PLANNING BOARD REPORT PORTLAND, MAINE

4-unit Condominium Development
31 Fore Street

Level III Site Plan and Subdivision Review
Peninsula Property Development, Applicant

Submitted to: Portland Planning Board Date: March 18, 2016 Public Hearing Date: March 22, 2016	Prepared by: Jean Fraser, Planner CBL: 016 J026001 Project #: 2016-005
--	--

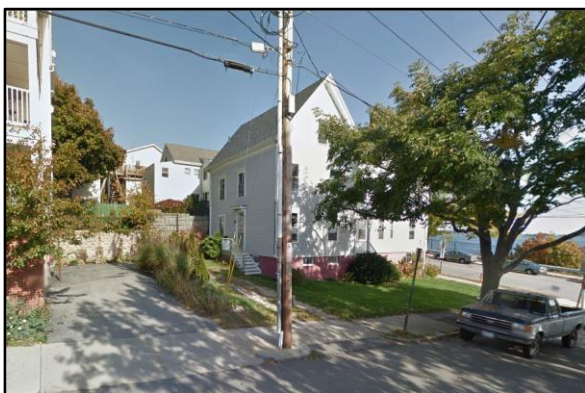
Waiver Requests to Planning Board	Applicable Standards
<i>Distance of driveway from corner:</i> The driveway is located 31.26 feet from the corner (Plan P4 and Att H) and a waiver is requested due to architectural constraints.	Technical Standard 1.7.1.7 requires “access driveways to corner lots shall be located a minimum of 35 ft from the intersection of the projection of right-of-way lines to the center line of the driveway”. The Traffic Engineering and Dept of Public Works reviewers support a waiver of 3.74 feet based on an understanding that the driveway location is constrained by the architectural requirements (Atts 5 & 6).
<i>Parking Drive Aisle:</i> Waiver required for parking drive aisle that is approximately 25.75 ft wide to facilitate maneuvering within the garage (Att H).	Technical Standard 1.14 <i>Parking Lot and Parking Space Design</i> require a drive aisle of 24 feet width for 90 degree parking. The Traffic Engineering Reviewer supports this waiver (Att 6).

<i>Street Trees:</i> Four street trees are required and there is only room for three in the ROW.	Site Plan Standard and waiver (<i>Section 14-526(b)2.b(iii)</i>), requires one street tree per unit. The City Arborist supports the applicant planting a 4 th small street tree just within the applicant’s site on Waterville Street frontage (Att 7)
